MEMO

DATE: September 20, 2016
TO: Planning and Sustainability Commission
FROM: Sallie Edmunds, Central City Planning Manager
CC: Susan Anderson, Director and Joe Zehnder, Chief Planner
SUBJECT: CC2035 Worksession on September 27, 2016

SUBJECT: Central City 2035 - Scenic Resources Protection Plan

Map C1: Old Town / Chinatown Heights

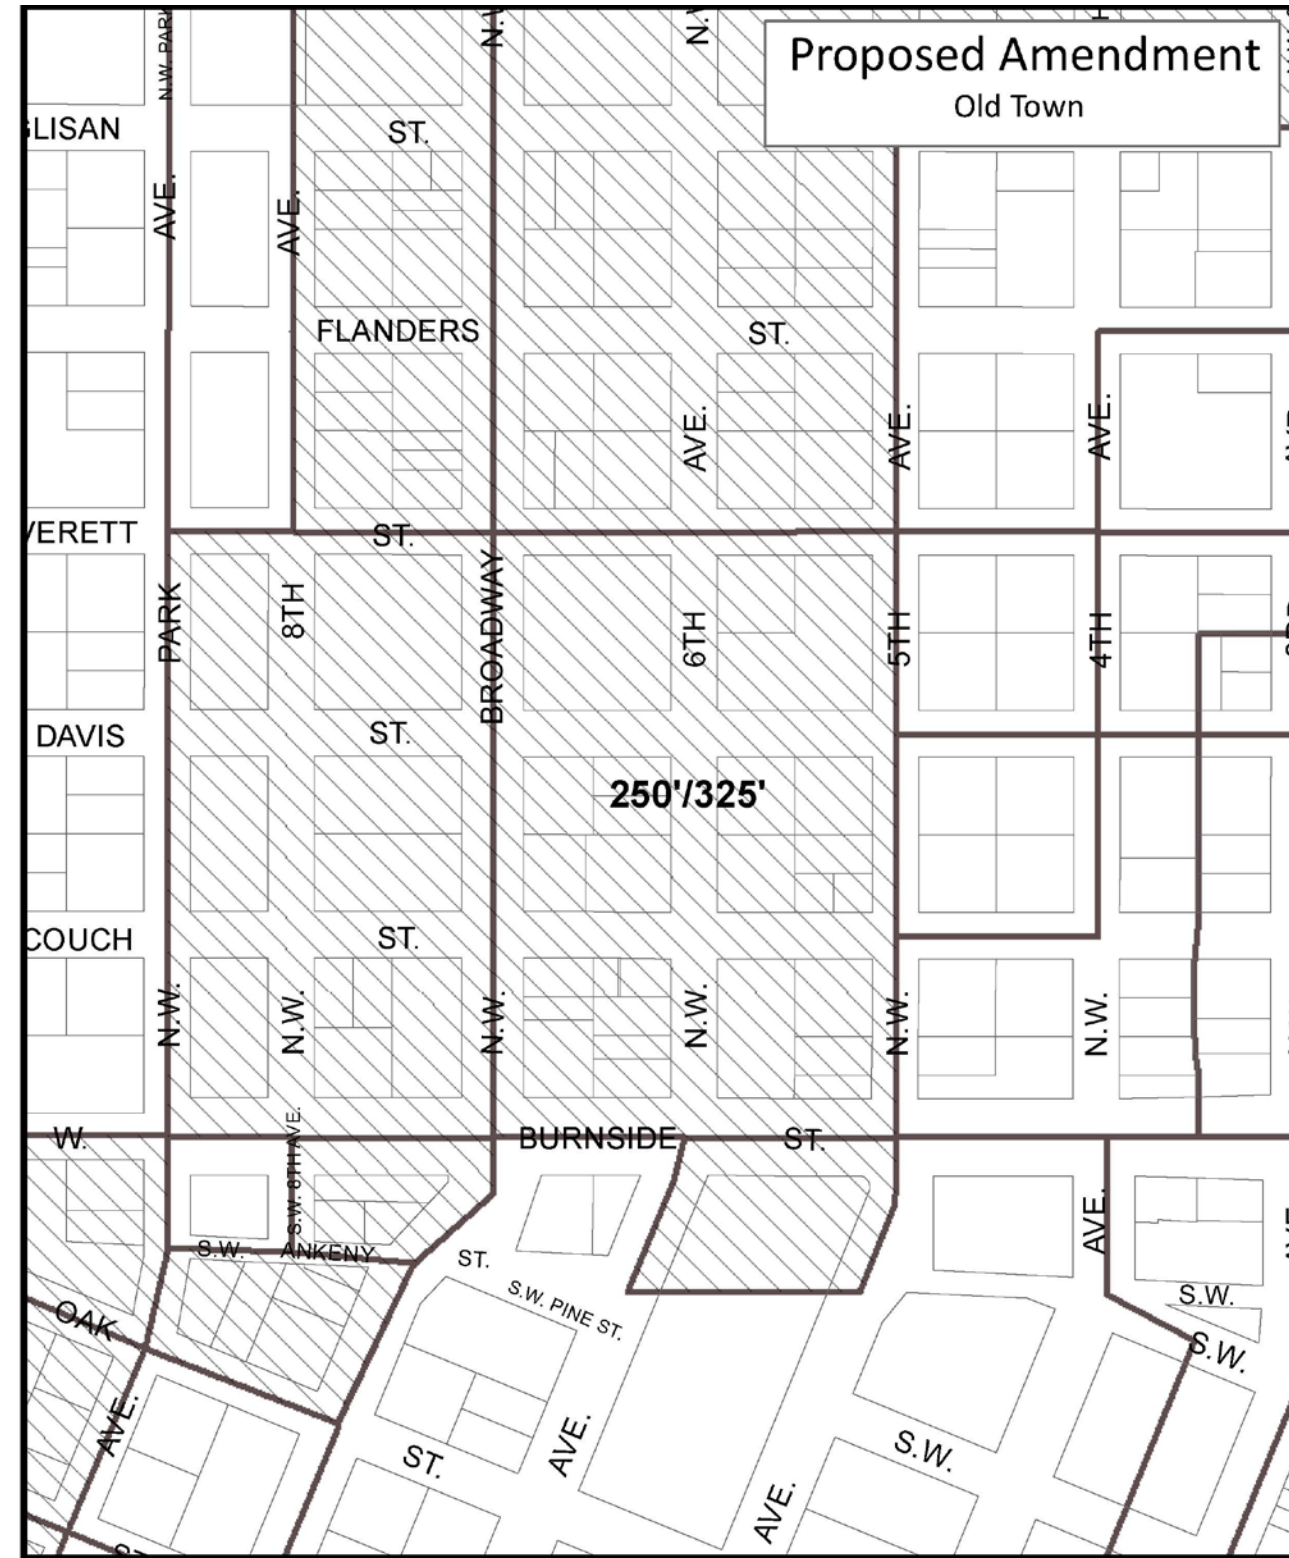
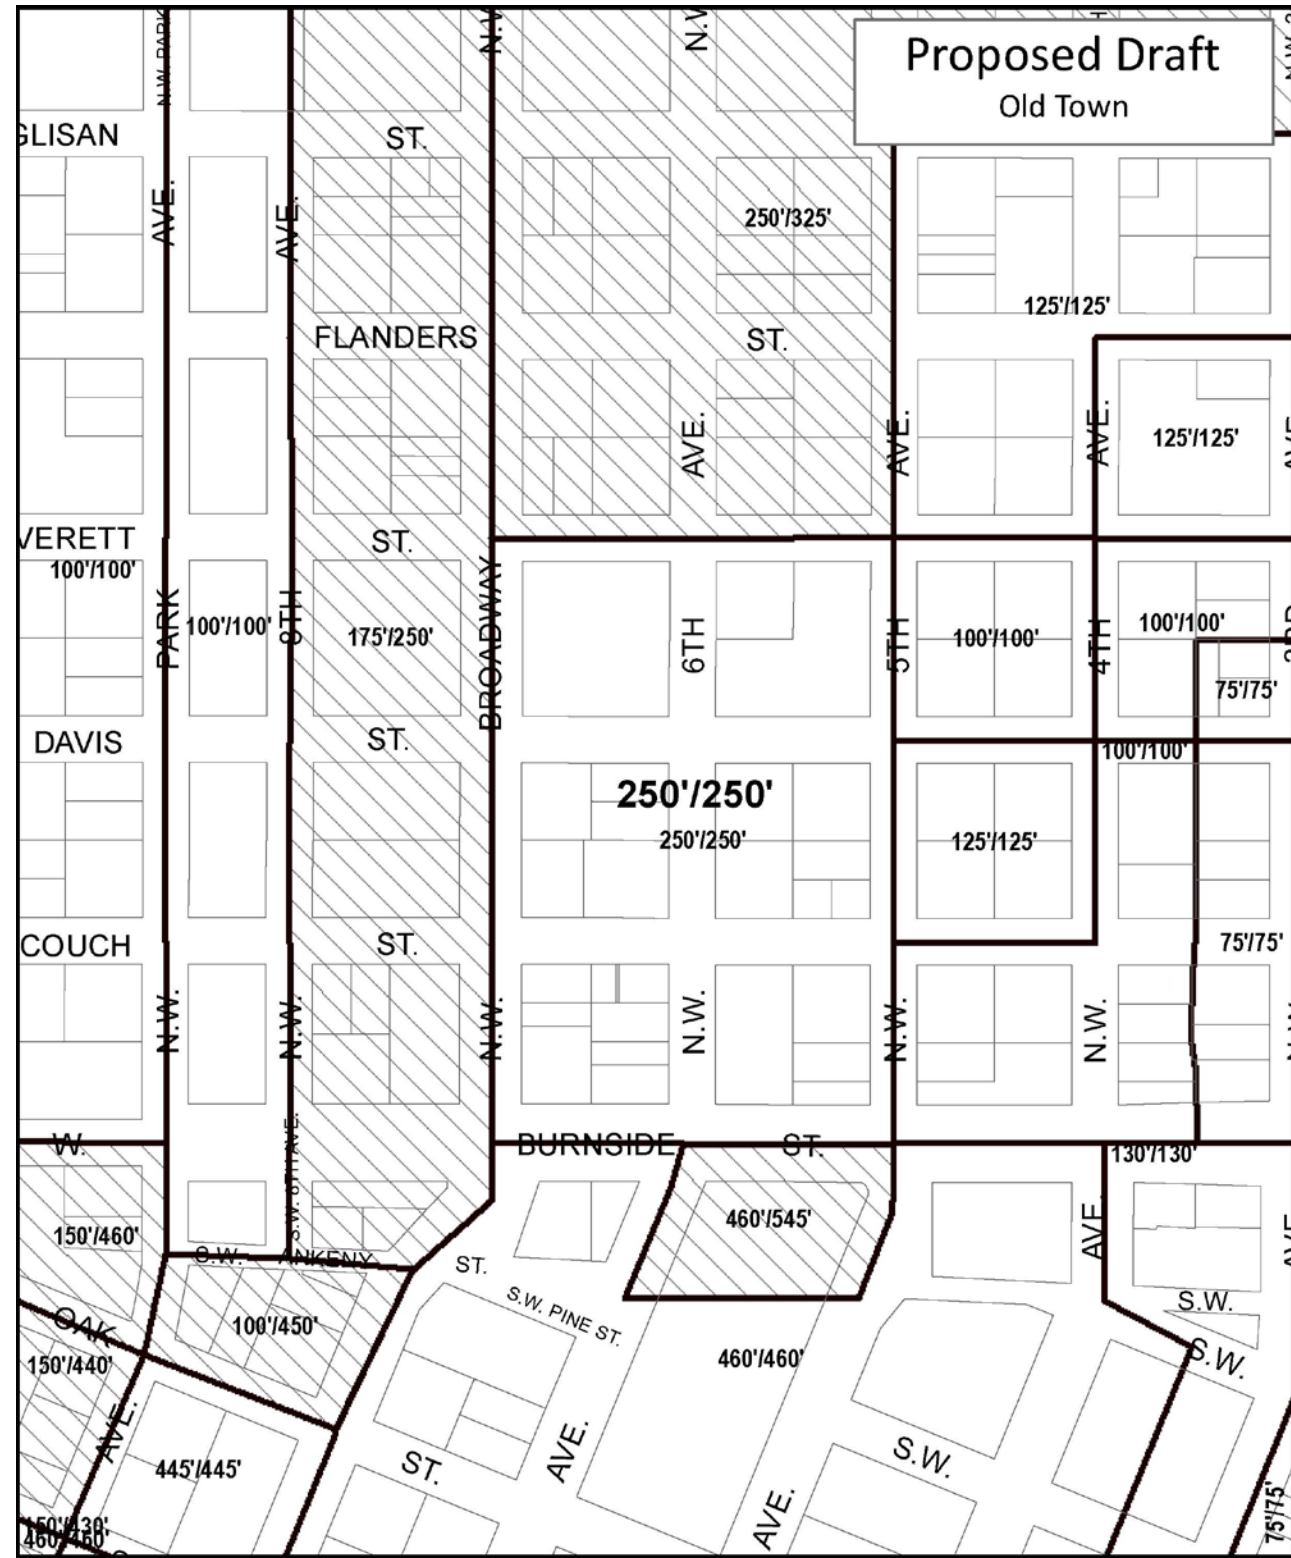
C19	20329, 20372	David Wark-- Portland Design Commission Julie Livingston-- Portland Design Commission	Central City	Minimum building heights are not specified. Maximum heights vary across the Central City.	Mandate minimum heights to ensure, dense urban-scale development.	Retain Proposed Draft version.	Staff <i>is</i> proposing minimum FARs (ranging from 1:1 to 3:1) across the Central City. This will help ensure minimum development density. Staff proposes maximum heights and FARs to allow for flexibility and various design options.	<input type="checkbox"/>	<input type="checkbox"/> Support staff rec. <input type="checkbox"/> Other

Map D: Revised SE 11th and 12th Height and Zoning Proposal

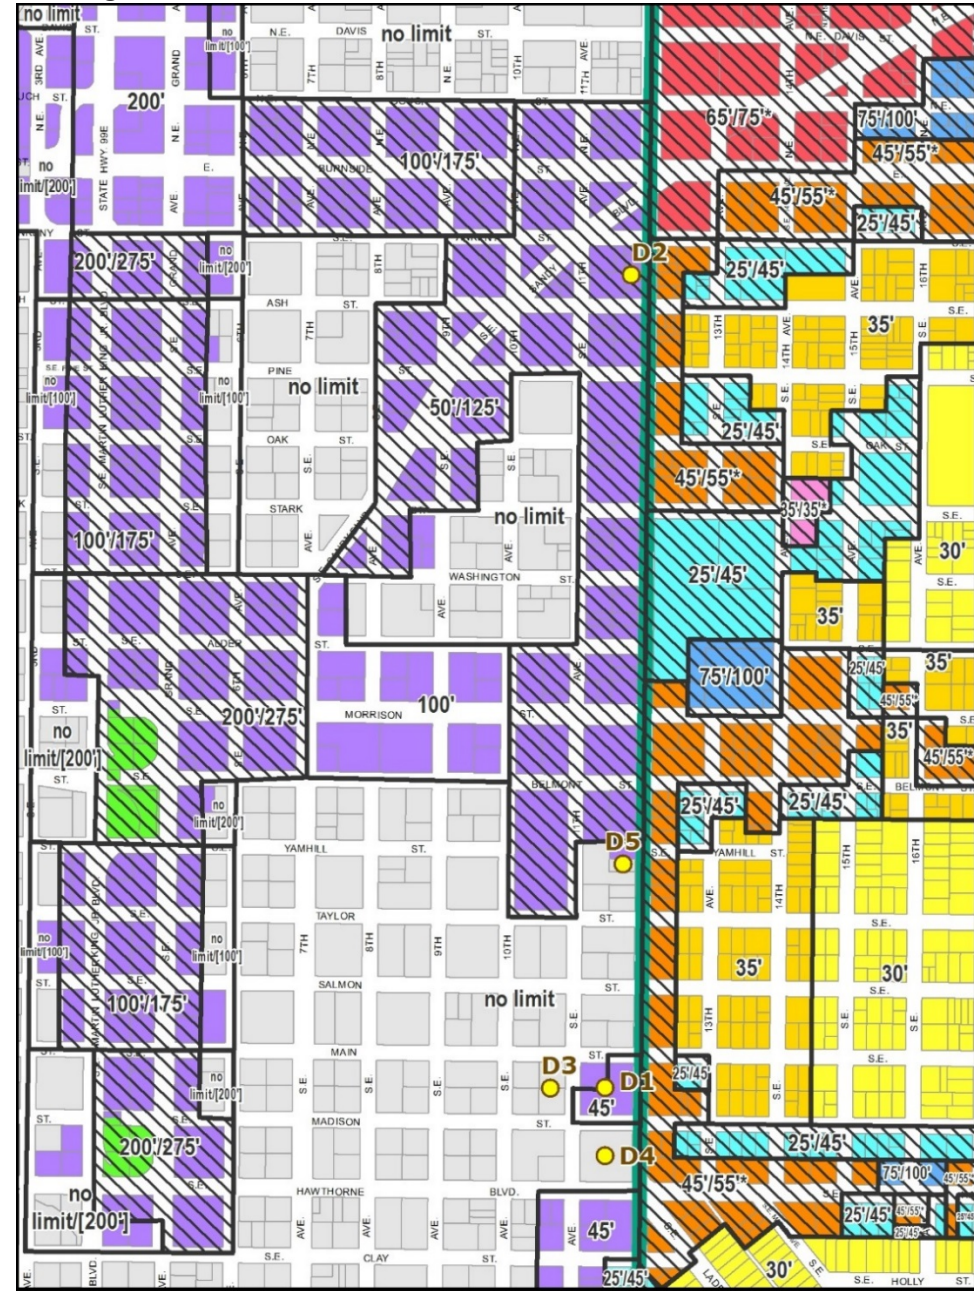
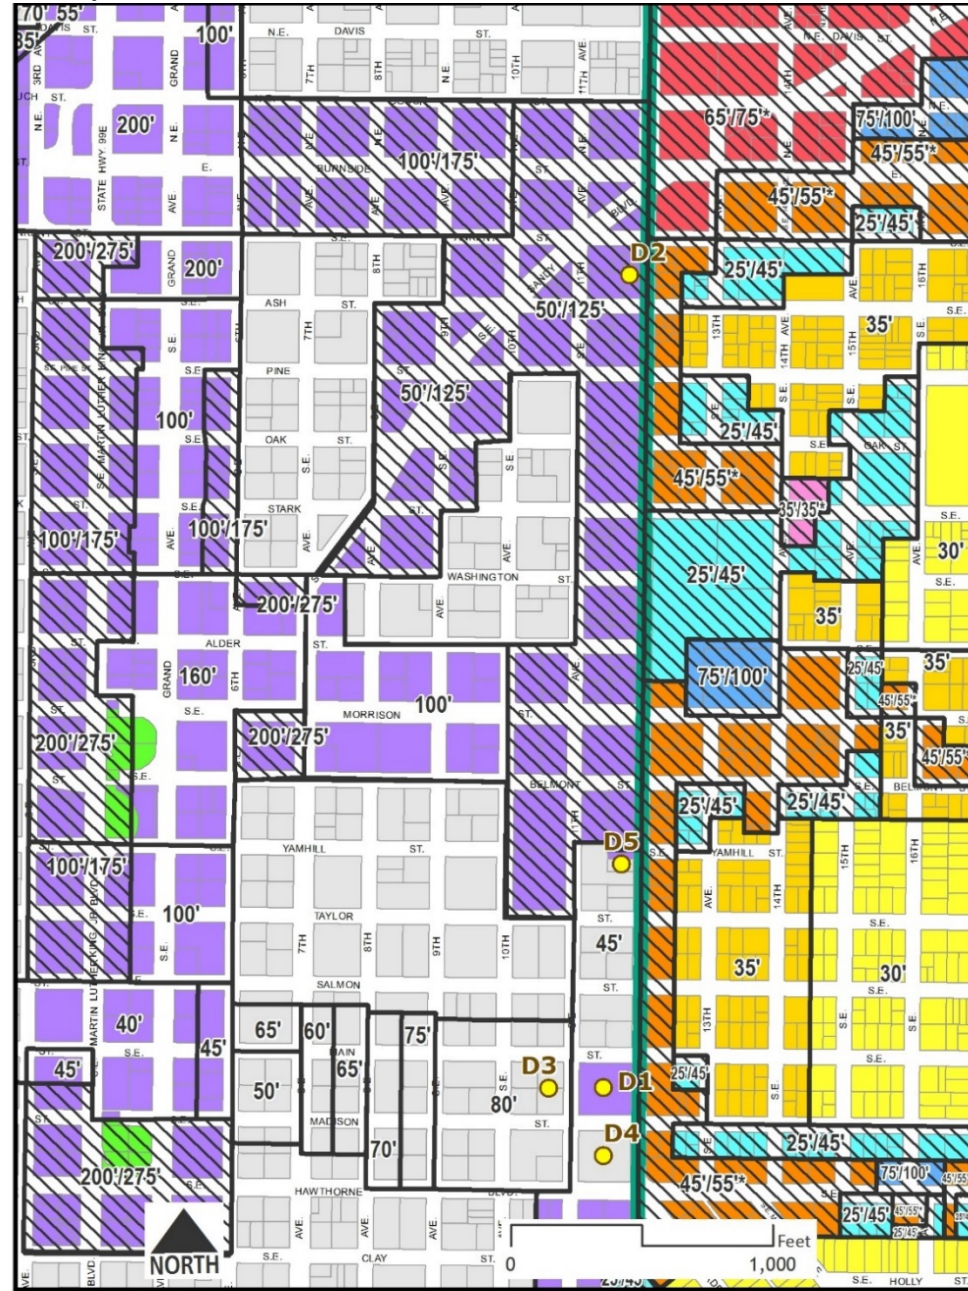
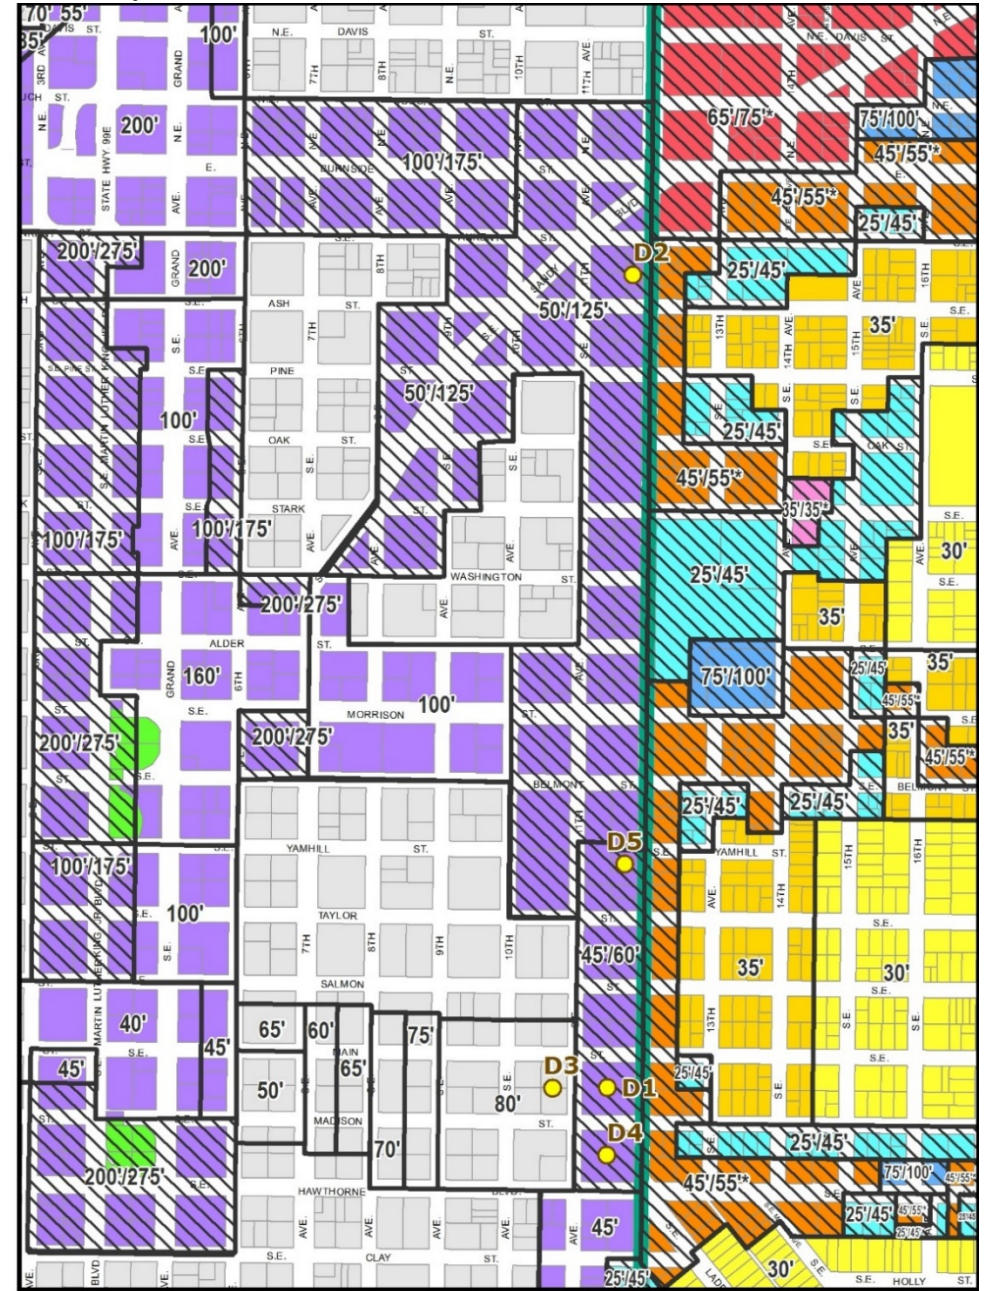
D5 and Map D	20983	Bhajan Kester	Zoning	Area: 1007 SE 12th Ave. Zoning: IG1 References: Vol 2A1, Proposed Zoning Map (pg. 468)	Zoning: EX or zone that makes places Victorian era homes in conformance with the Zoning Code.	New proposal: For the four IG1 zoned blocks between SE Yamhill and SE Hawthorne: <ul style="list-style-type: none"> • Rezone to EX. Note: No action is needed if the staff recommendation for D4 is supported.	There are only four blocks in the East 11th/12th corridor between NE Couch and SE Clinton Streets that are not zoned EX, RH or R1, so rezoning would be consistent with surrounding zoning while meeting the needs of the property owner.	<input type="checkbox"/>	<input type="checkbox"/> Support staff rec. <input type="checkbox"/> Other
